Re: Collection Station 47 – Response to Form 27 COAs (Document # 401894372)

Client/Project
 Chevron EMC
 Rangely CS-47B No. 10501

Title
 CS-47b - EVALUATION OF WATER BEARING ZONE

Figure No.
 1

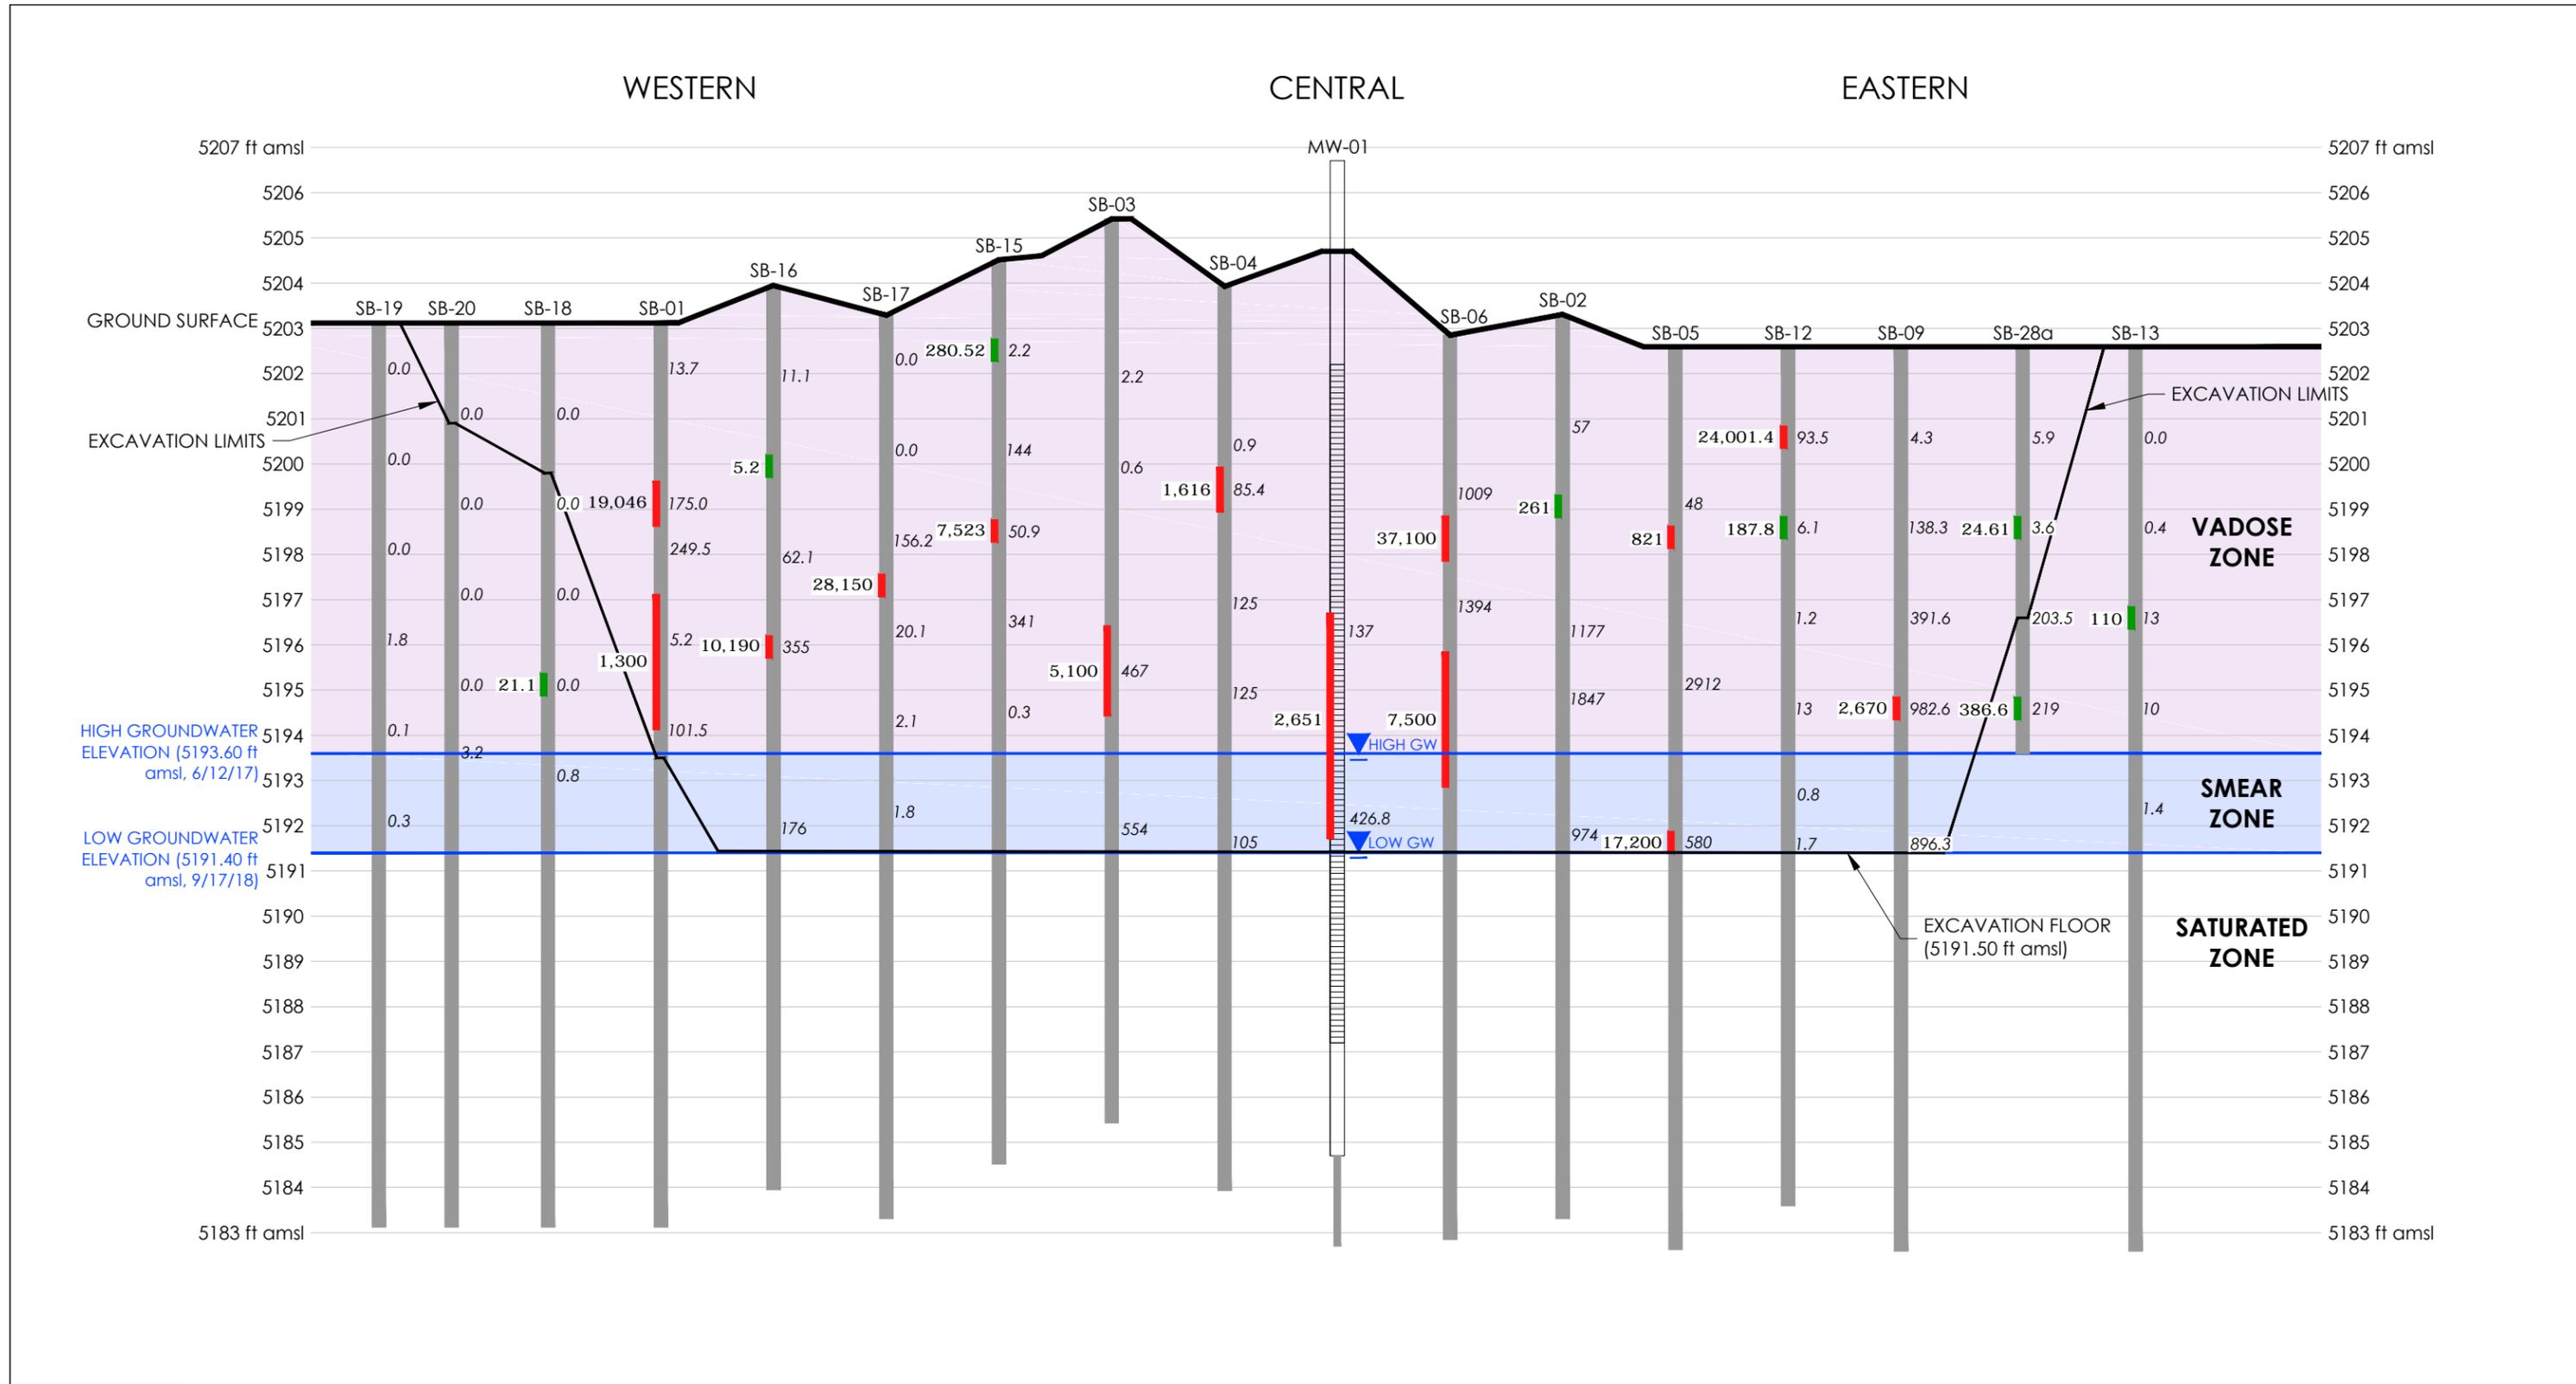
COA #1 - *Prior to the COGCC issuing a no further action (NFA), a soil boring shall be advanced in the areas with the most elevated impacts of TPH (SB-06, SB-1, SB-17, and in the vicinity of MW-01R). Samples shall be collected in the smear zone from about 12.5 feet below ground surface (bgs) to about 14.5 feet bgs and analyzed for BTEX, TPH-GRO, and TPH DRO.*

Response #1: As shown on **Figure 1** (attached), the remedial excavation at CS-47B extended to the bottom of the smear zone. Data collected from MW-1/MW-1R during the past seven gauging events indicate groundwater elevation ranges from a low of 5,191.40 feet above mean sea level (ft. amsl) to a high of 5,193.57 ft. amsl. During the CS-47B remedial excavation, all hydrocarbon-impacted soil was removed from the vadose zone and smear zone at SB-06, SB-17, and in the vicinity of MW-1/MW-1R as the excavation extended to a depth of 5,191.50 ft amsl. At SB-01, the remedial excavation extended to just below the high groundwater elevation since there were no visual and olfactory indications or photoionization detector (PID) readings that indicated hydrocarbon impacted soil was present.

As demonstrated above and shown on **Figure 1**, further assessment within the smear zone does not provide additional value. CEMC respectfully requests the COGCC reconsider their request for additional assessment and closure of CS-47B. Justification to support closure includes:

1. Vadose zone and smear zone soils exceeding COGCC Table 910-1 Concentration Levels have been removed;
2. Benzene, toluene, ethylbenzene, and total xylenes (BTEX) concentrations in groundwater have never been detected above Table 910-1 Concentration Levels during any of the groundwater sampling events; and
3. Liquid hydrocarbons are not present.
